21	SILL
12	A6.2

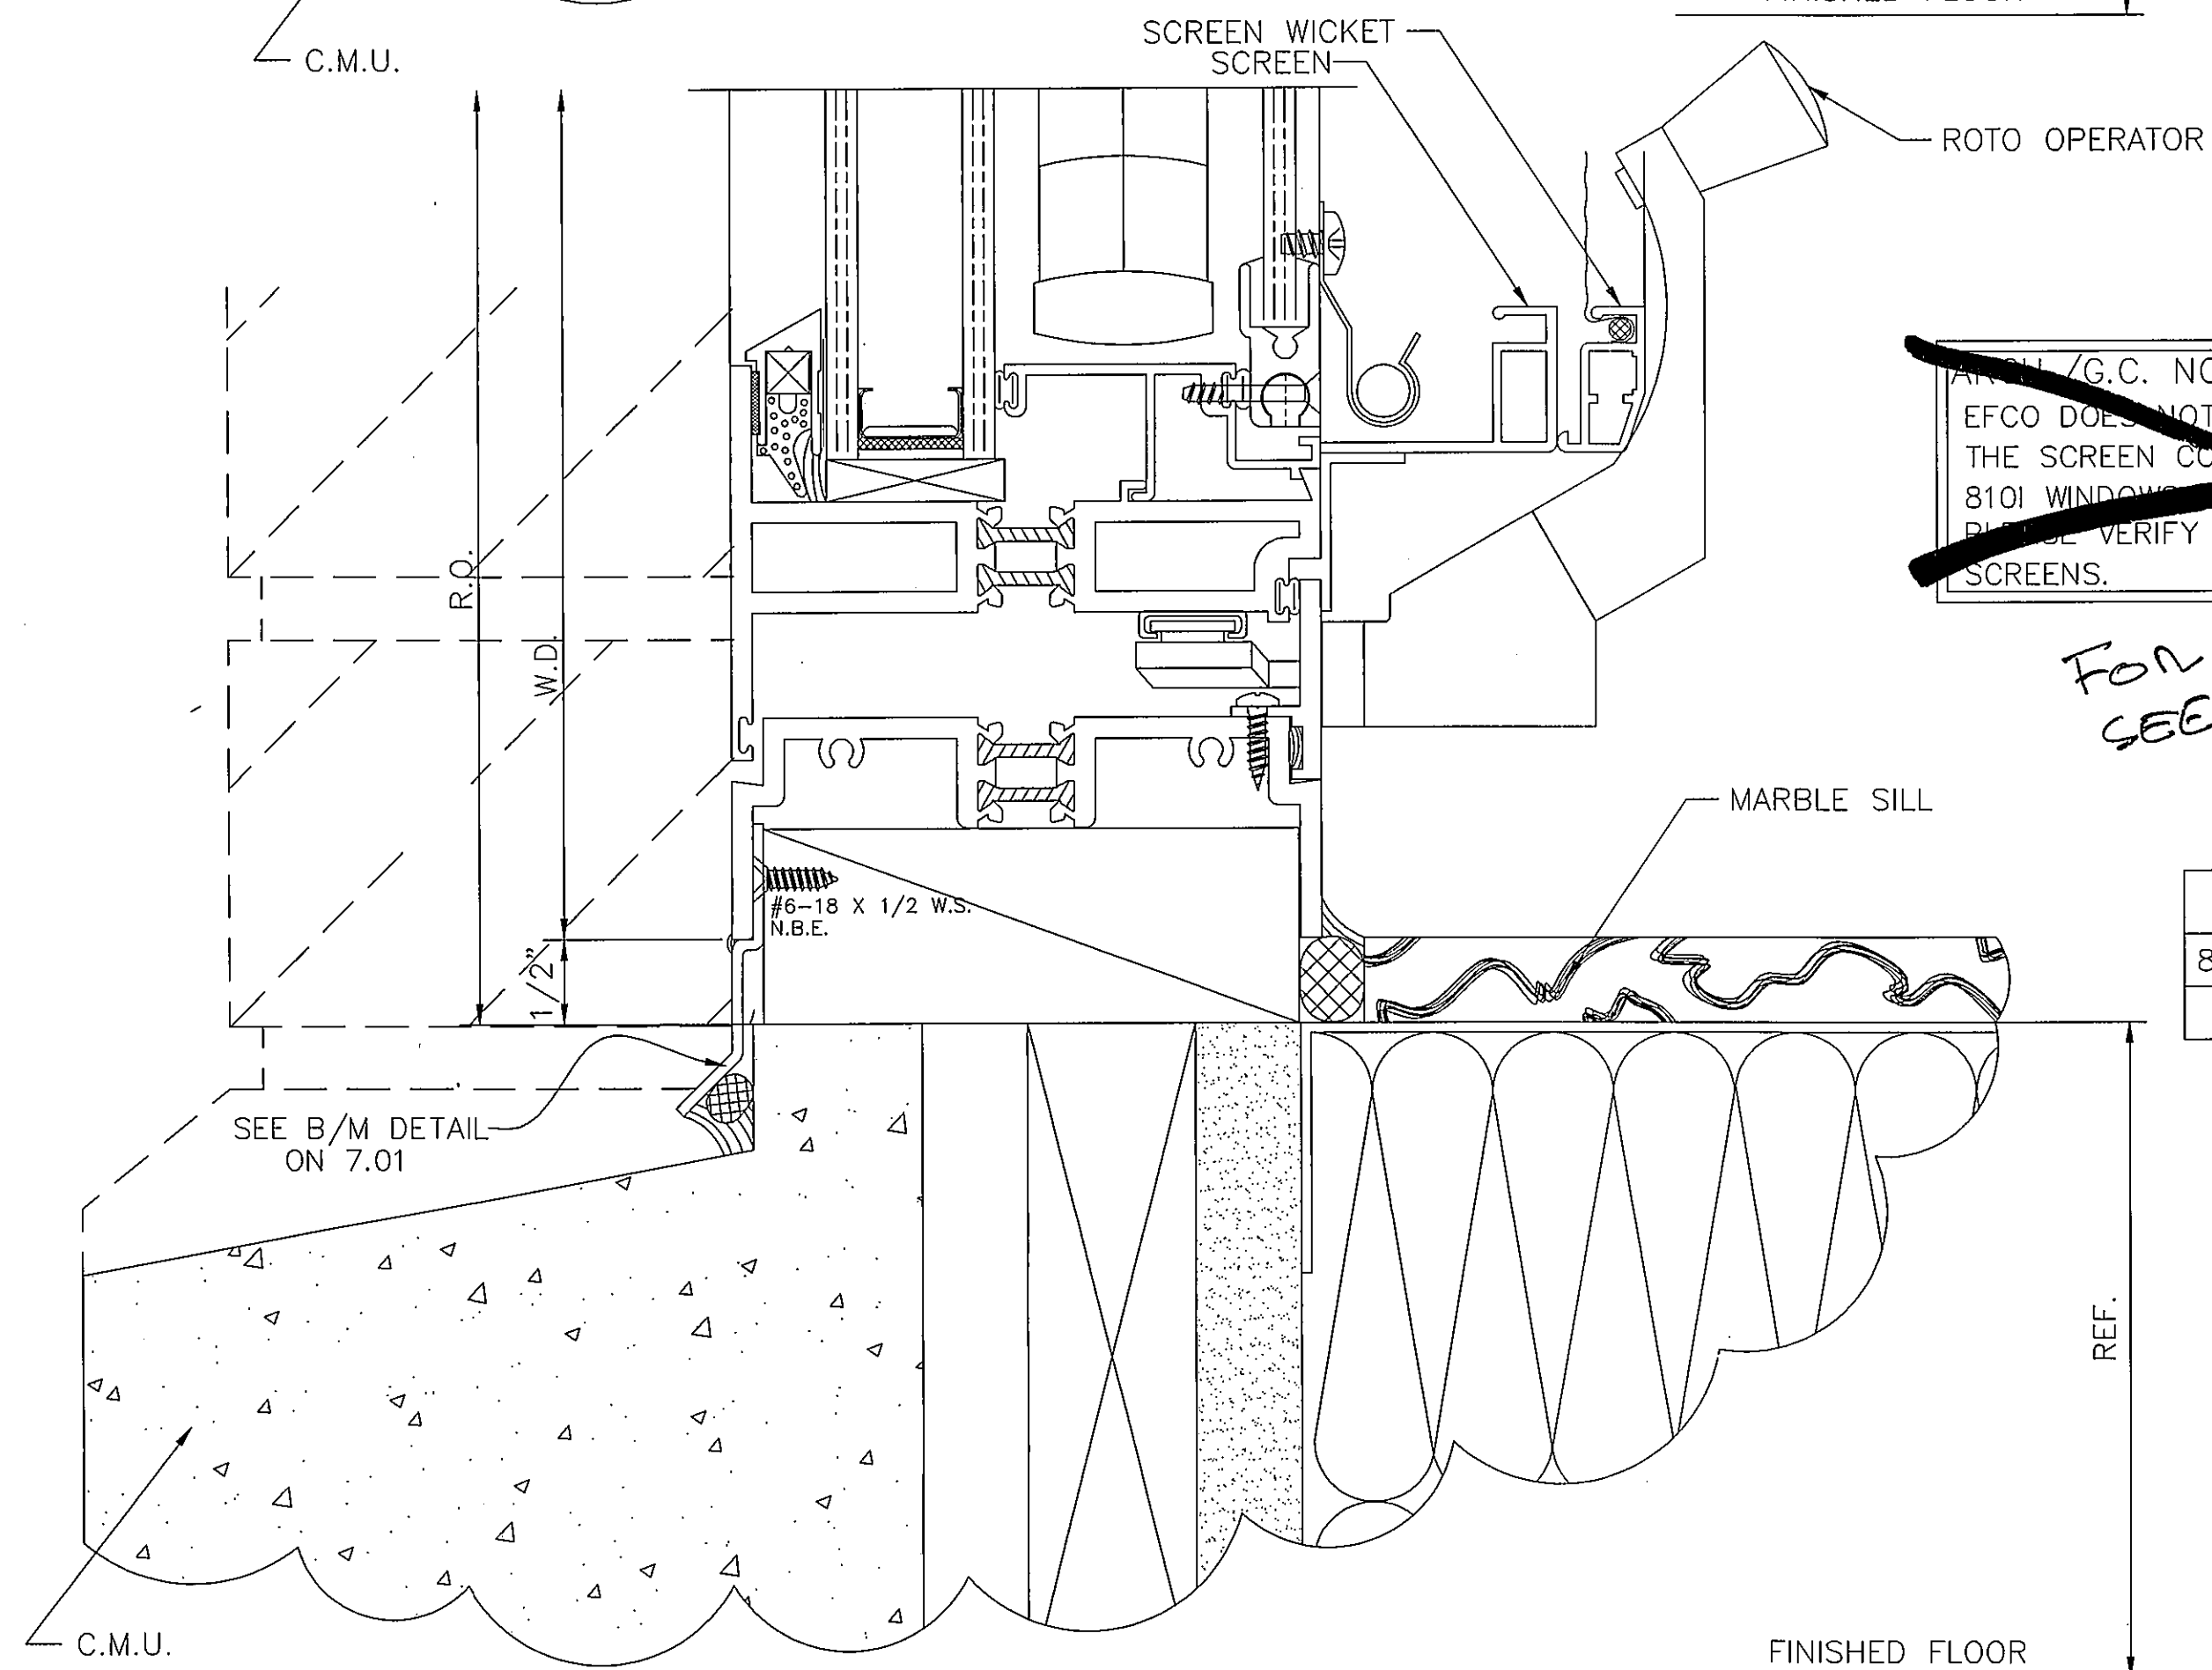
~~ARCHITECT'S NOTE:~~
~~EFCO DOES NOT HAVE AN ALTERNATIVE TO~~
~~THE SCREEN CONFIGURATION SHOWN ON THE~~
~~8101 WINDOW DETAIL AND ROTO'S.~~
~~PLEASE VERIFY THE USE OF THE CURRENT~~
~~SCREENS.~~

FOR SCREEN DETAIL
 SEE 10/704
